Subject: Response to Request for Additional Information Regarding License Amendment
Application for Measurement Uncertainty Recapture Power Uprate
(License Amendment Request No. 05-0007) (TAC No. MD5240)

RESPONSE TO REQUEST FOR ADDITIONAL INFORMATION

DAVIS-BESSE NUCLEAR POWER STATION, UNIT NO. 1

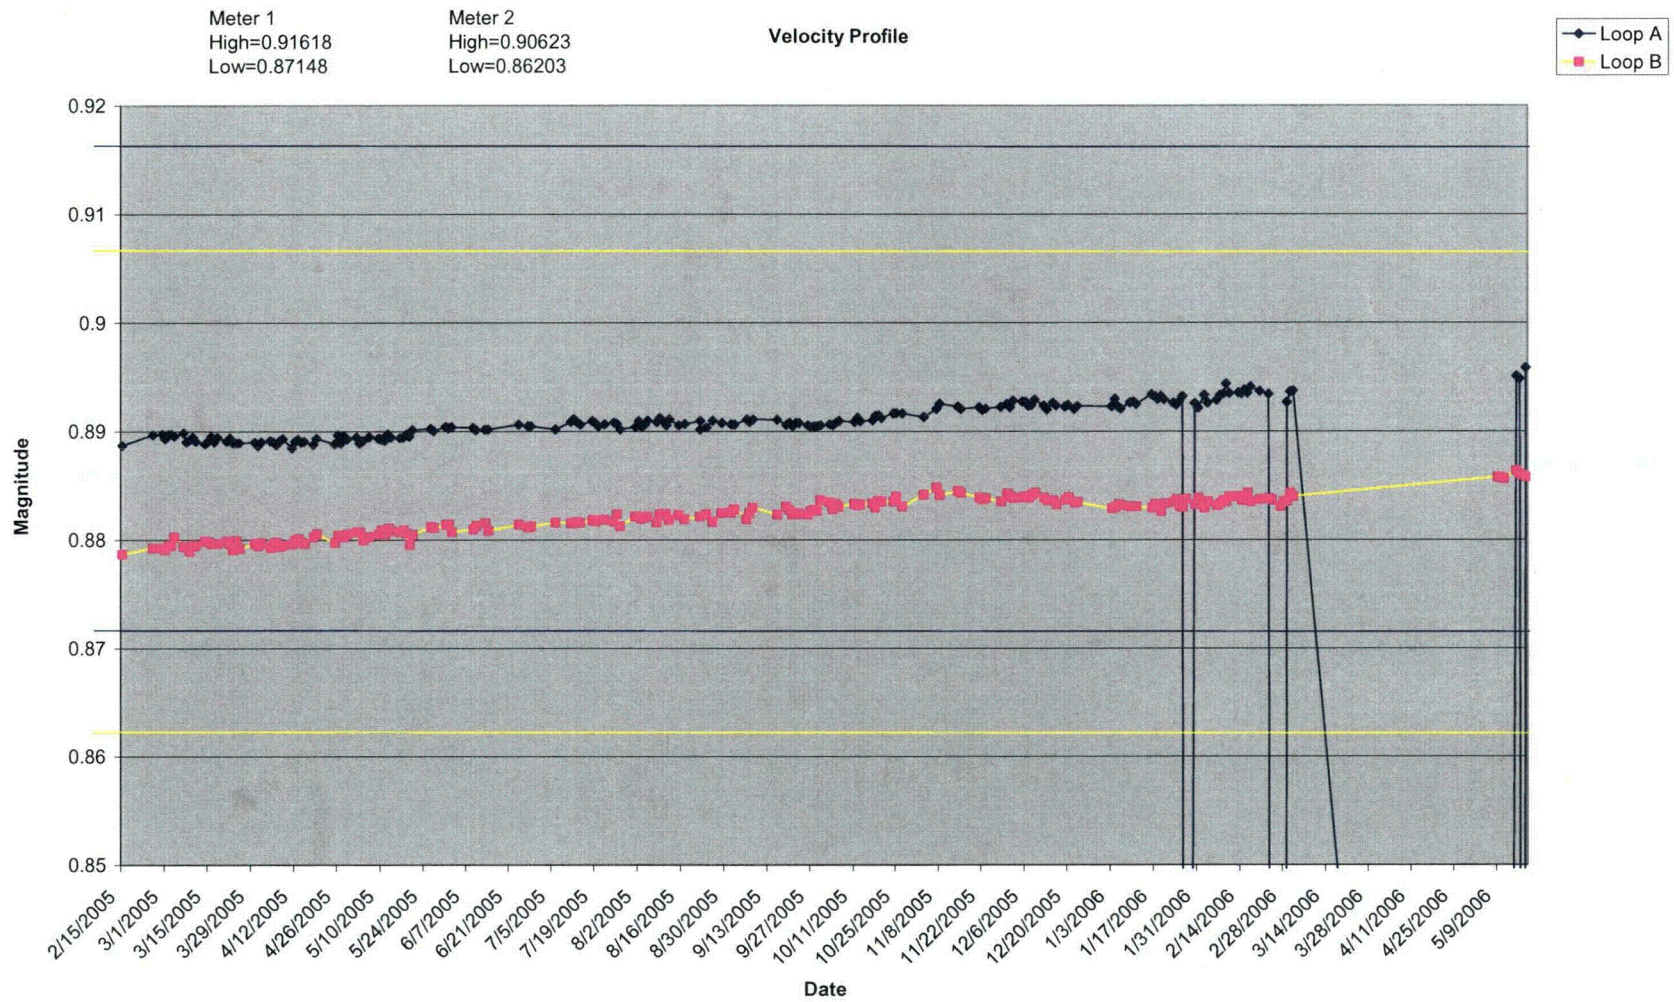
22. SRXB: Please provide a summary of the Alden Laboratory test results and application/comparison of those test results to plant operation. Include a representative set of test data if not provided in Request 21, above.

The following graph shows a trend of the velocity profiles from February of 2005 until May 2006. This plant data is consistent with velocity profile data shown in Table 3 (page 9) of ER-227 (Enclosure 10). The rise in the velocity profile of the plant data is believed to be due to the decreasing signal to noise ratio as the transducers aged over time.

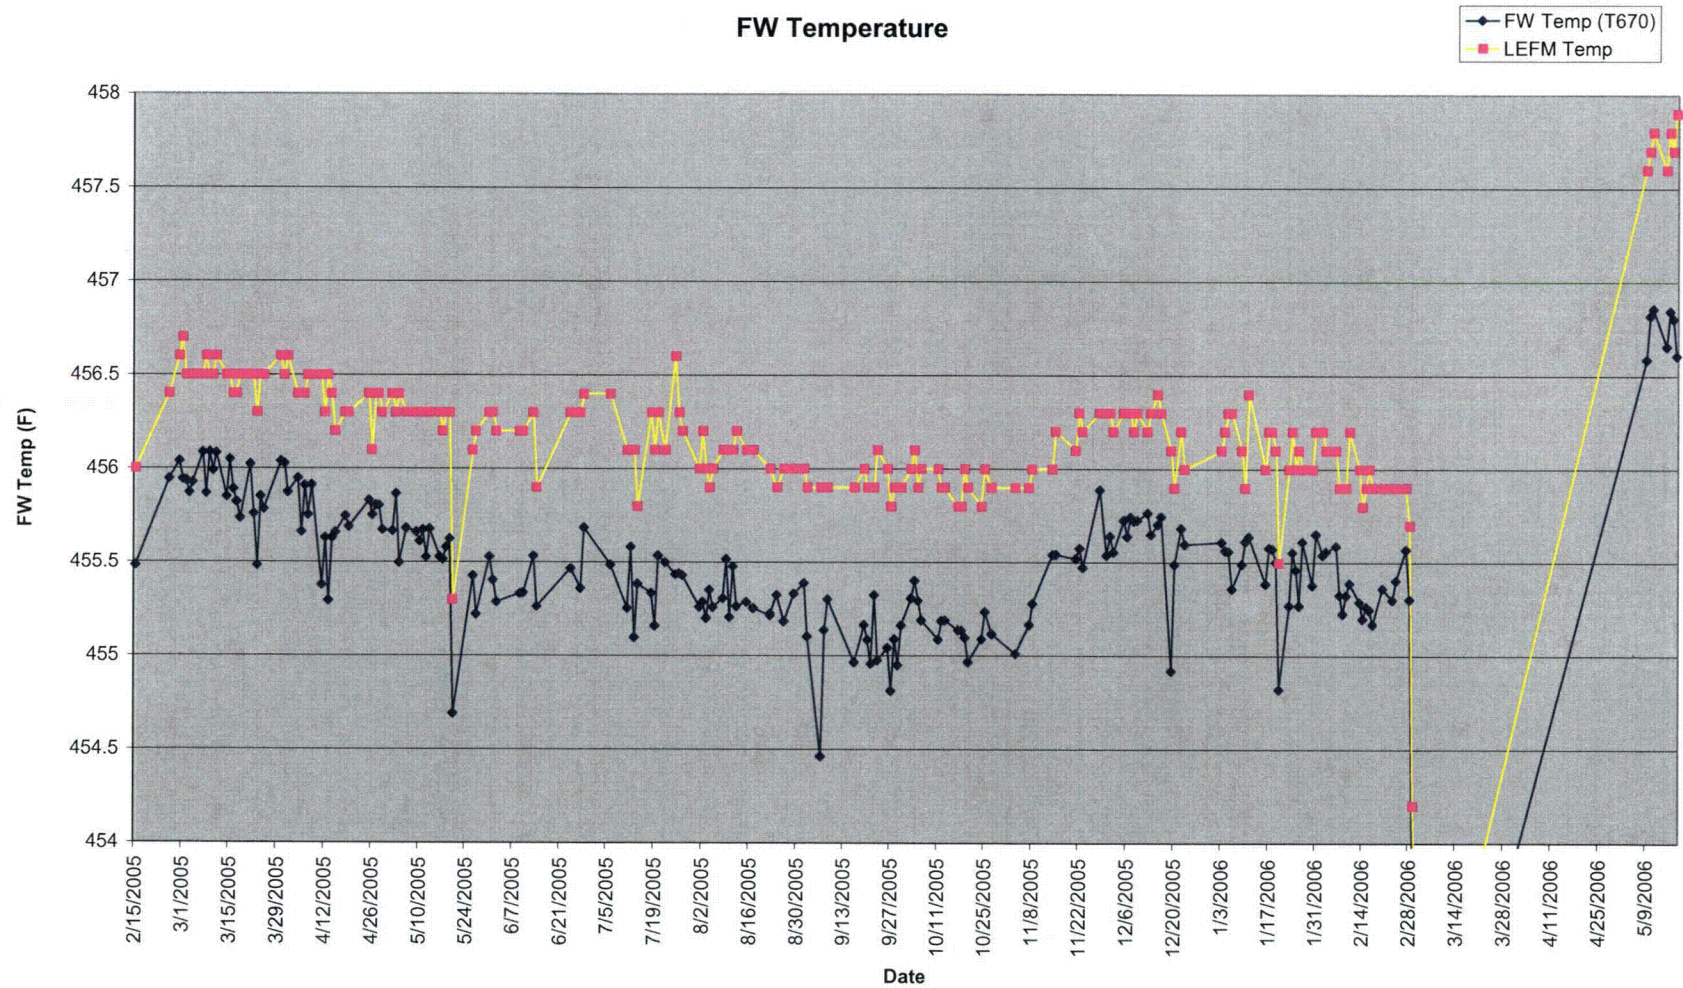
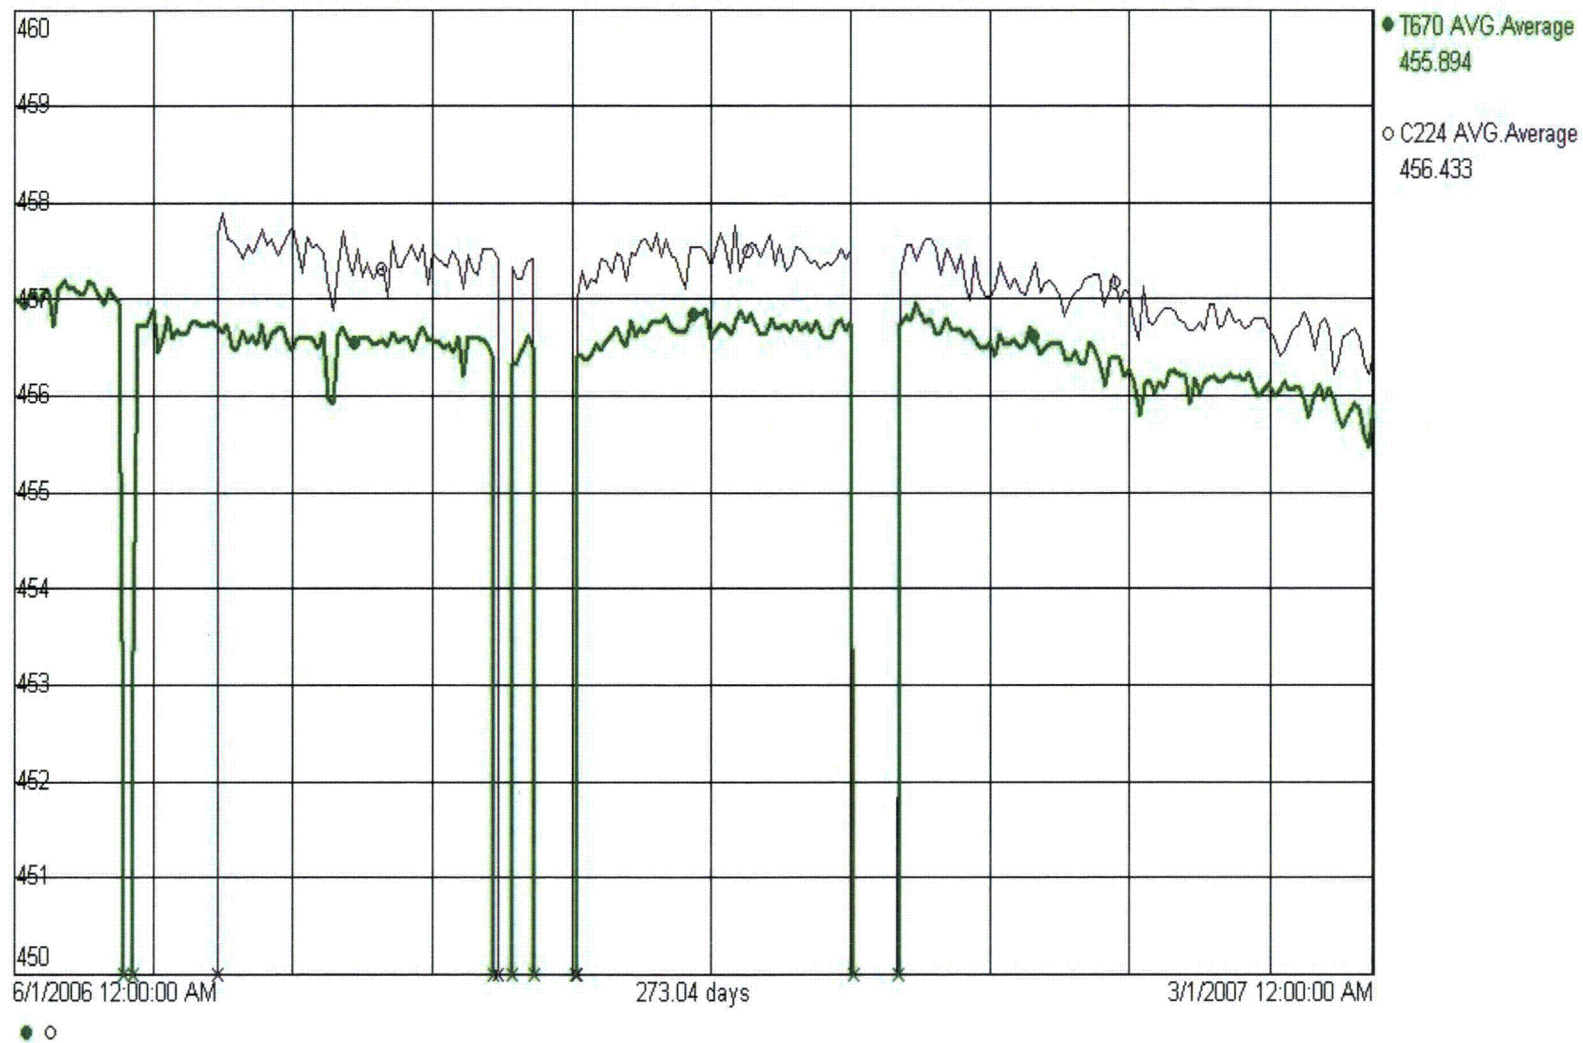
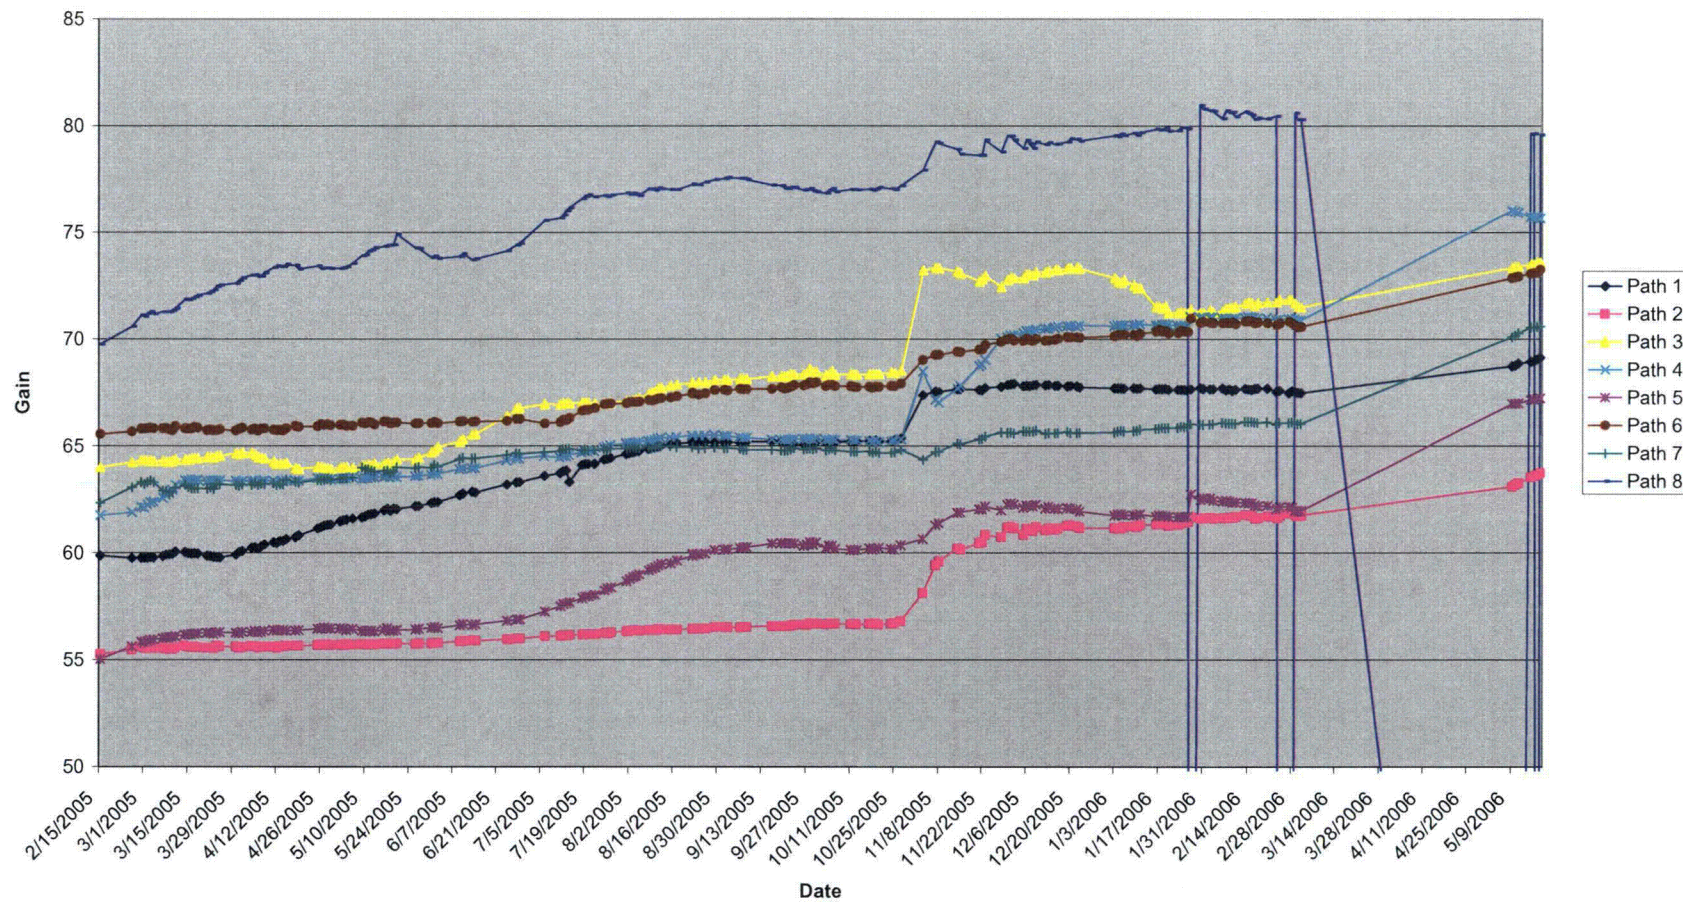
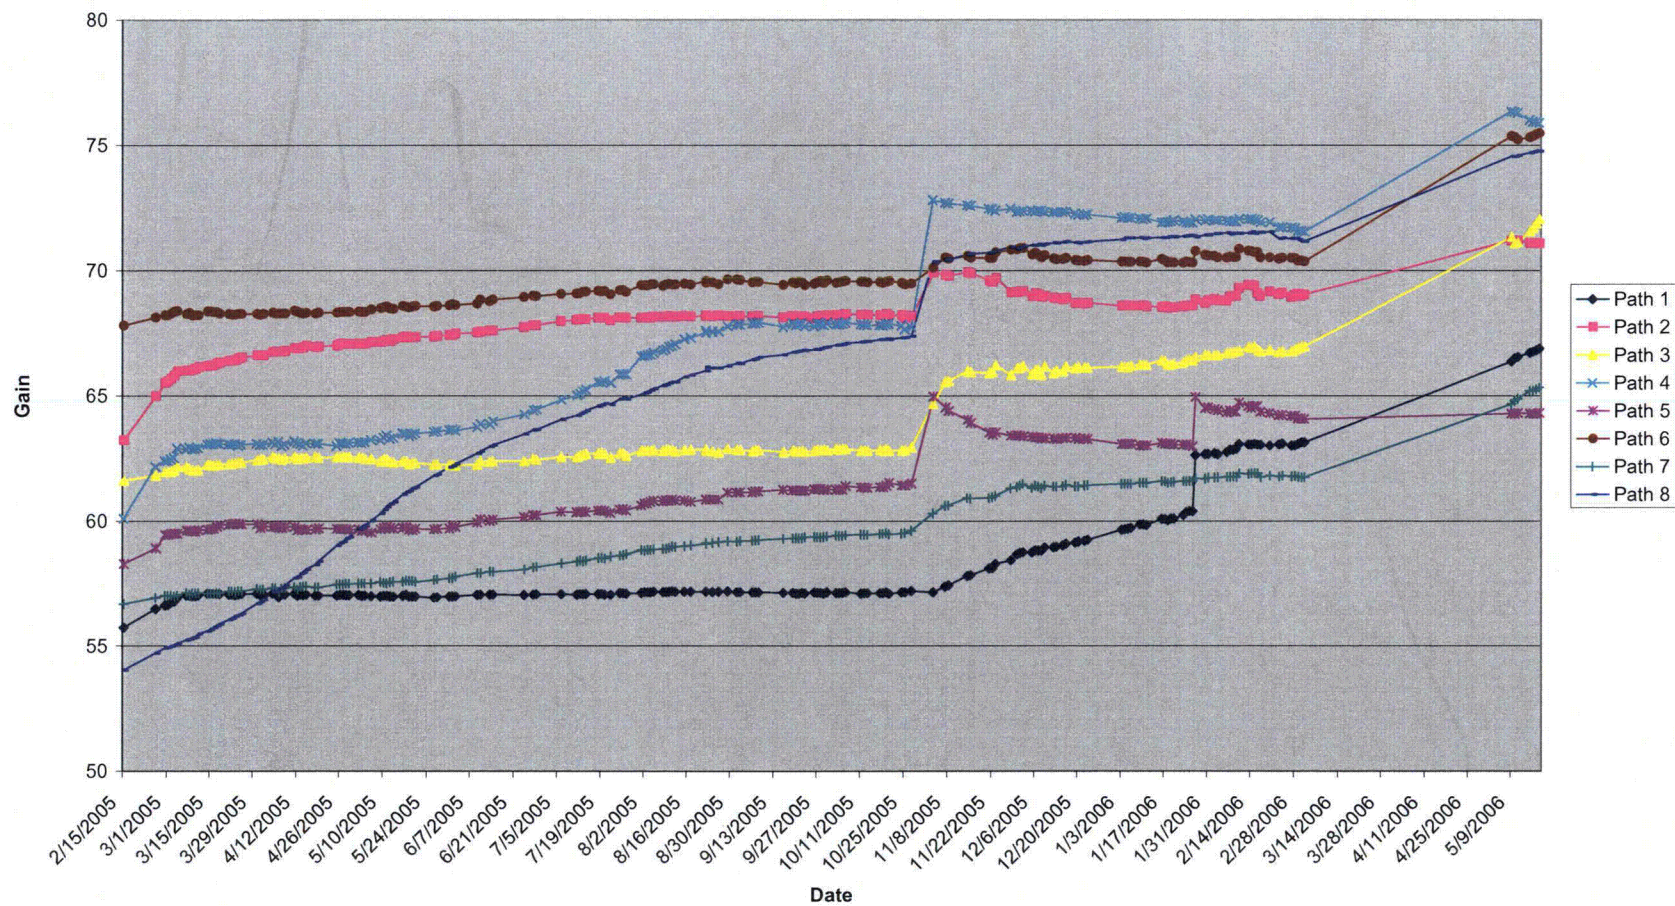
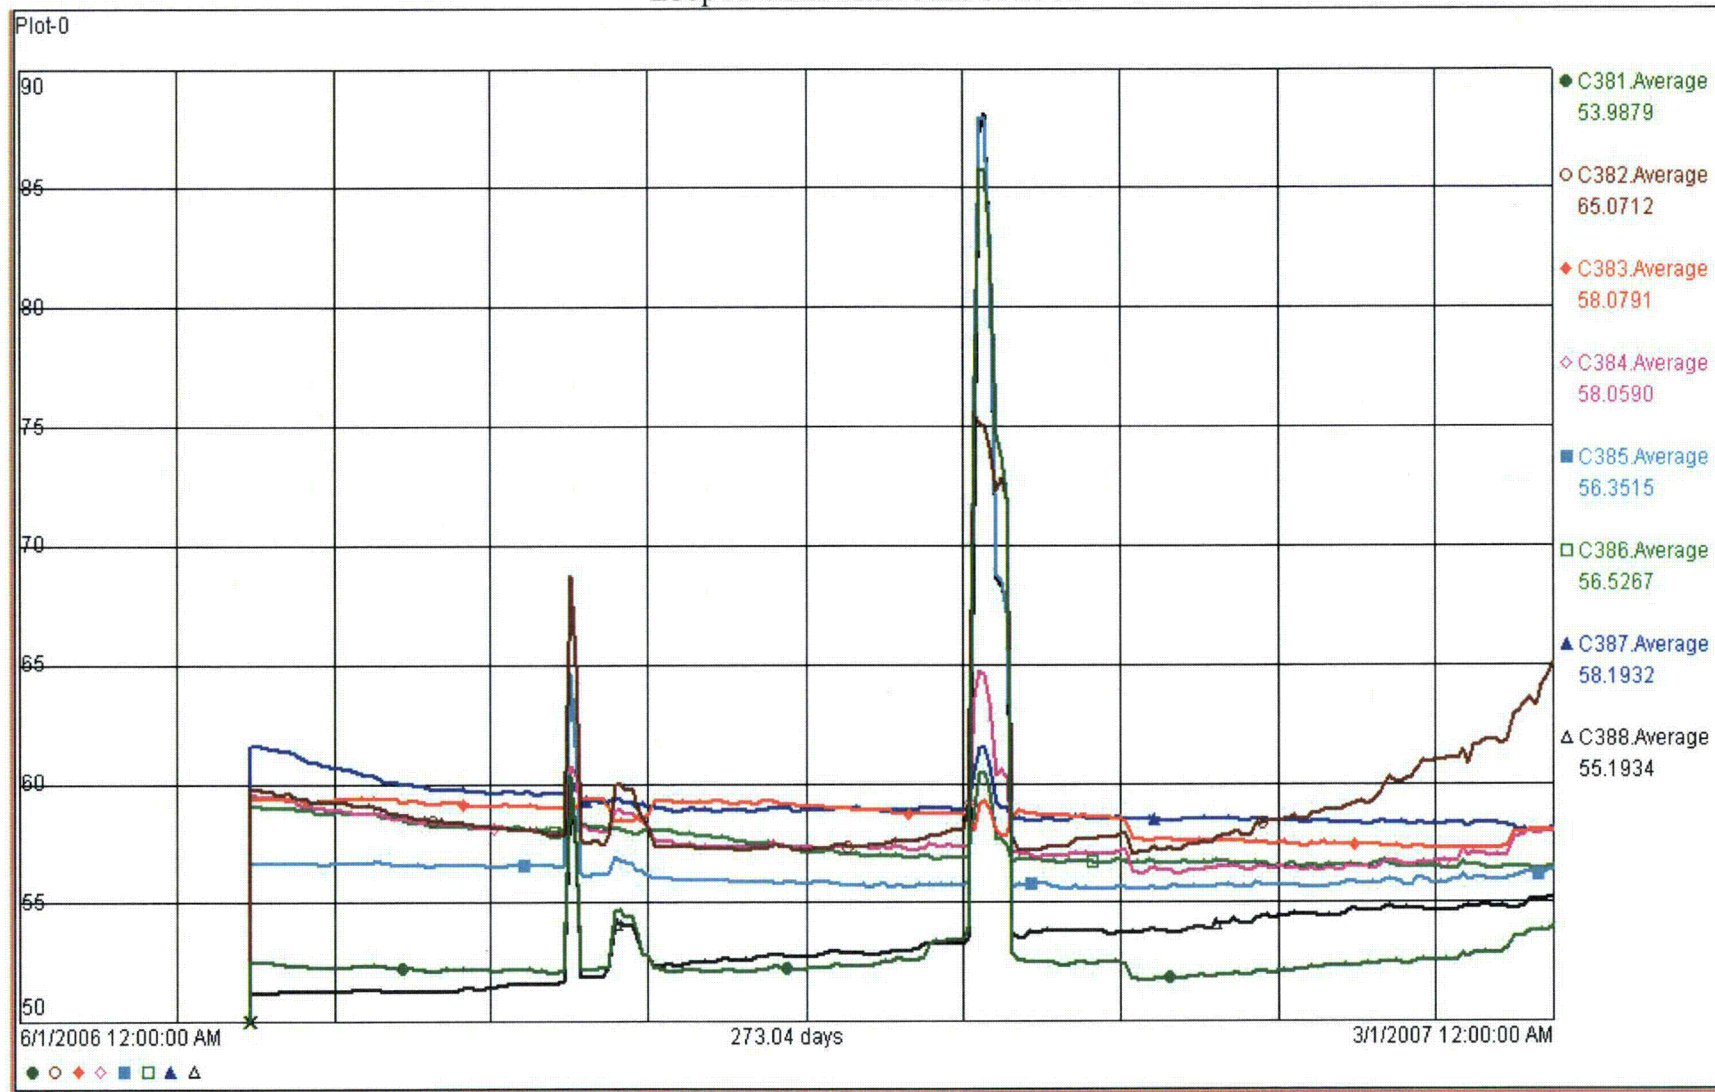
- 23. SRXB: Please provide a summary of LEFM characteristics before and after replacement of the 32 transducers in June 2006. This summary should contain a comparison to other feedwater measurement instruments over a sufficient time span to enable a valid comparison of before and after characteristics.**

- Feedwater temperature output of the LEFM and RTD prior to and after June of 2006.
- Pathway gains prior to and after June of 2006.

A review of the data for Feedwater (FW) temperature, which is one of the inputs to the heat balance calculation, shows consistency in trending between computer point C224 (LEFM FW temperature) and computer point T670 (RTD FW temperature) before and after June of 2006. The trends in LEFM FW temperature show no changes in the performance before or after the change out of the transducers in June of 2006. The downward spike in data for the graph of FW temperature prior to June of 2006 was due to the 14th Refueling Outage (14RFO). The downward spikes in the data for the graph of FW temperature after June of 2006 were due to plant maintenance outages or maintenance on the LEFM.

In summary, there were no identifiable effects observed in the data due to changing out of the transducers in June of 2006. Data was collected on the performance of the transducers after the change out and verified by Cameron that the LEFMs were performing within specifications.
